Office Action Summary	Application No. 10/633,368	Applicant(s) LAYTON ET AL.	
	Examiner Amy J. Sterling	Art Unit 3632

This is the first Office Action for application number 10/633,368 Shock-Resistant Enclosure, filed on 7/31/03. Claims 1-35 are pending.

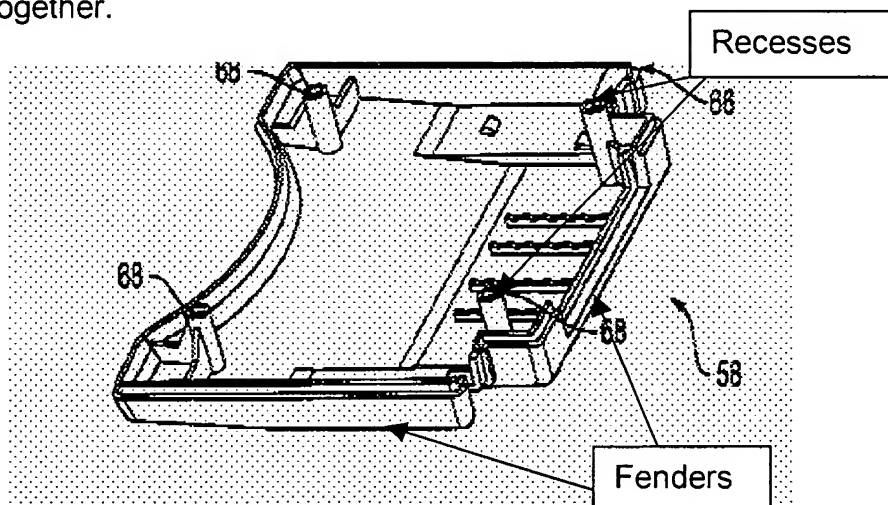
Claims 1-3, 6-12, 17-20 and 32 are rejected under 35 U.S.C. 102(e) as being anticipated by United States Patent No. 6454250 to Ribeiro.

The patent to Ribeiro discloses a shock-resistant enclosure (54, 56, 58) having a housing to which a fragile element is rigidly mounted (electronic component, See Col. 3 line 64) and a plurality of integrally formed elastomeric (See Col. 3, line 63 for material) discrete shock absorbing elements (54, projections being sides 74, 76) projecting in

different directions and from different sides of the housing and extending beyond a mounting surface of the housing, wherein the shock absorbing elements are a gasket having a sealing portion (74) disposed between the base and cover (56, 58) which seals two sections a base and cover section (56, 58) of the housing together, and shock absorbing elements (62, See Drawing Below) which are formed integrally with the housing and are the same material as the housing which include an integrally formed mounting pad (62) which projects from the housing and integrally formed fenders (See Drawing Below) spaced laterally from mounting pad (62) which extend around corners and are spaced from corner portions of the housing. Riberior also teaches wherein the shock absorbing elements are connected to the sealing portion by runners (78, 80) which are embedded in the walls of the housing and wherein the runners (78, 80) are embedded in recesses (See Drawing Below) near the corners of the housing and held in place by cornerpieces (68) retained by fasteners (60) that also hold the two sections of the housing together.

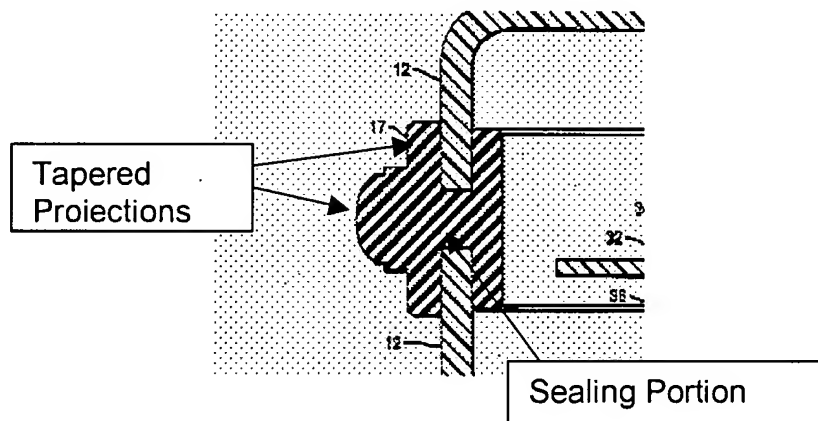
Claims 1, 5, 10 and 14 are rejected under 35 U.S.C. 102(b) as being anticipated by United States Patent No. 5550712 to Crockett.

The patent to Crockett discloses a shock-resistant enclosure (10) having a housing with a base (18) and cover (16) section, to which a fragile element (14) is rigidly mounted and a combined sealing gasket and shock absorbing structure formed integrally of elastomeric material (See Co. 4, lines 21 for material, silicone rubber is considered an elastomer) with a sealing portion (See Drawing Below) disposed between the base and the cover sections of the housing and plurality of discrete shock absorbing elements (17, See Drawing Below) extending from the sealing portion and are projecting from the different sides of the housing, the projections which are tapered and decrease in cross-sectional area away from the housing and are projecting in different directions from the housing.

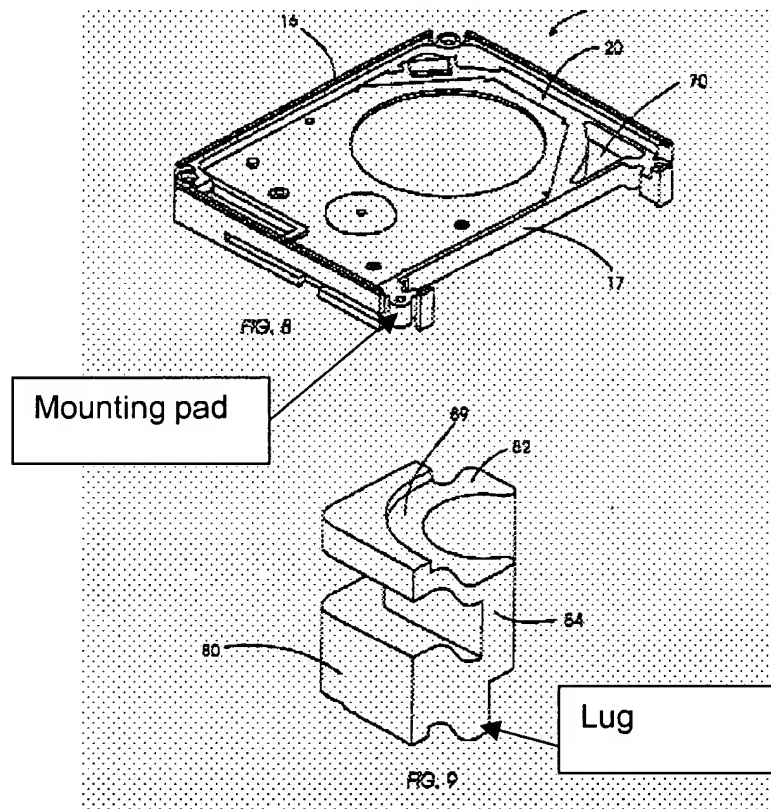
Claims 1, 19, 21, 23, 32, 33 and 35 are rejected under 35 U.S.C. 102(b) as being anticipated by United States Patent No. 6031841 to Albrecht et al.

Albrecht et al. teaches a housing (10) to which a fragile element (40) is rigidly mounted, and discrete shock absorbing elements projecting in different directions from the housing, the shock absorbing elements which include a generally circular mounting pad (See Drawing Below) which projects from the housing and a generally c-shaped shock absorbing fenders (80) which extend around corner portions and are spaced laterally from the corner portion and the mounting pad and the fender which includes a lug (See Drawing Below) which extends beyond a surface of the mounting pad and extend beyond a side of the housing bounded by the corner portions.
